AGENDA
Board of Zoning Appeals
June 17, 2008
7:00pm

PETITION NUMBER(S):
V08-017

COMMUNITY DEVELOPMENT STAFF ANALYSIS

SITE PLAN for V08-017
Submitted 5/6/08

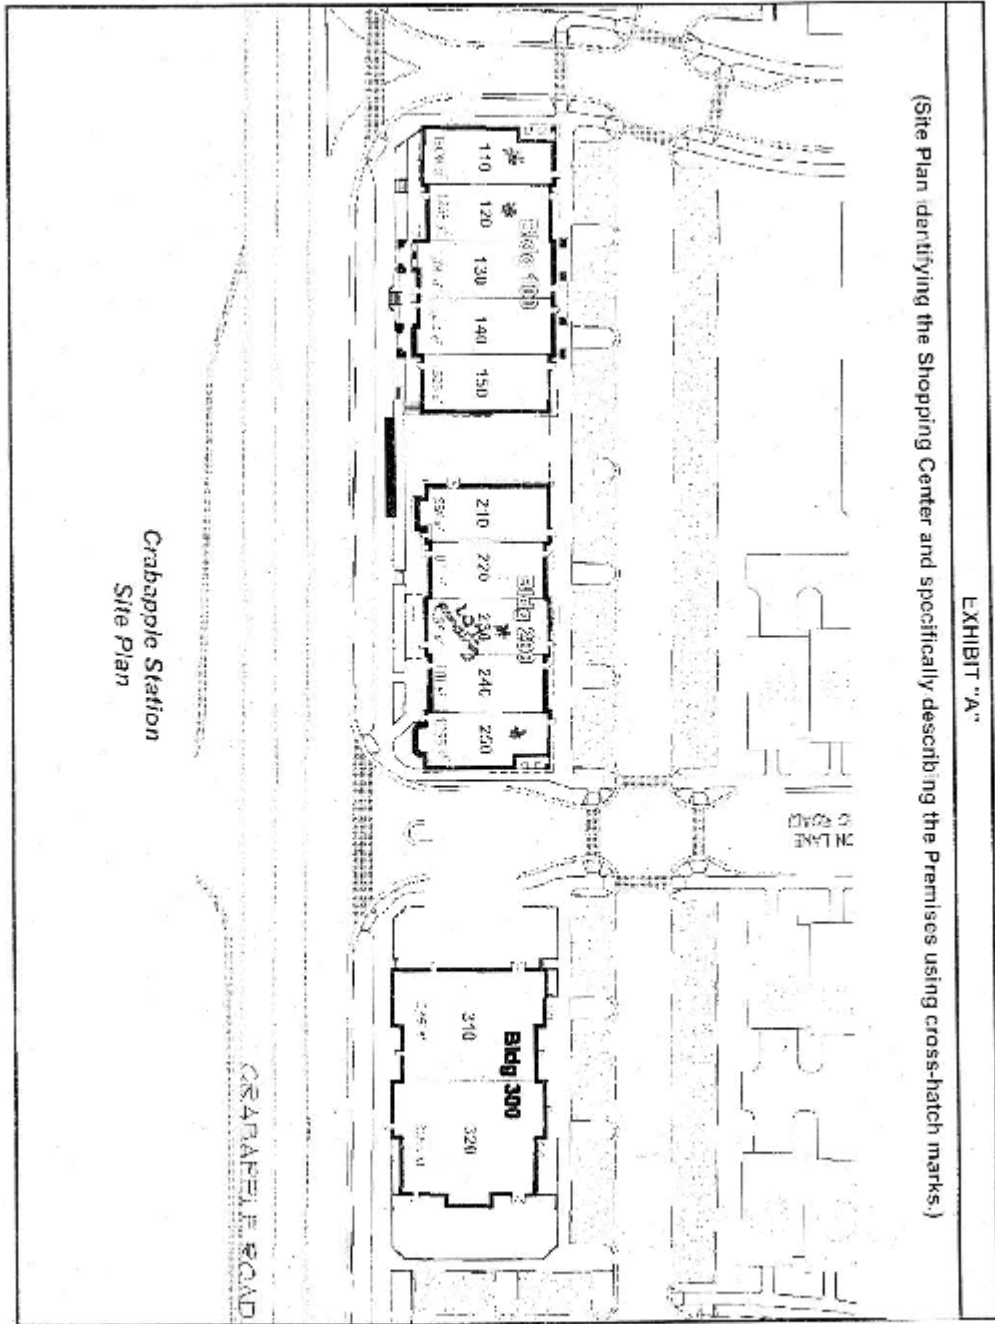
BUILDING PLAN REVIEW STAFF CONTACT MELISSA HENDERSON 678.242.3292	<i>The vents were not shown on the submitted building plans. The work platform around the gooseneck vent is missing, as well. It may not be possible to lower the height due to building codes (requires further research). A different style vent may be possible. Possibly screen with a three sided enclosure faced with siding to match building (in lieu of variance).</i>
SITE PLAN REVIEW STAFF CONTACT JIMMY SANDERS 678.242.2543	<i>NO ISSUES</i>
ARBORIST STAFF CONTACT MARK LAW 678.242.2552	<i>NO ISSUES</i>
DOT/STORMWATER REVIEW STAFF CONTACT JIM SEEBA 678.242.2559	<i>NO ISSUES</i>

1. Paint the vents to match the color of the roof/metal awnings.
2. Replace the gooseneck intake vent with a style that is lower in height, per approval of the Chief Building Official.
3. Add work platform to exhaust vent, as required by Code.
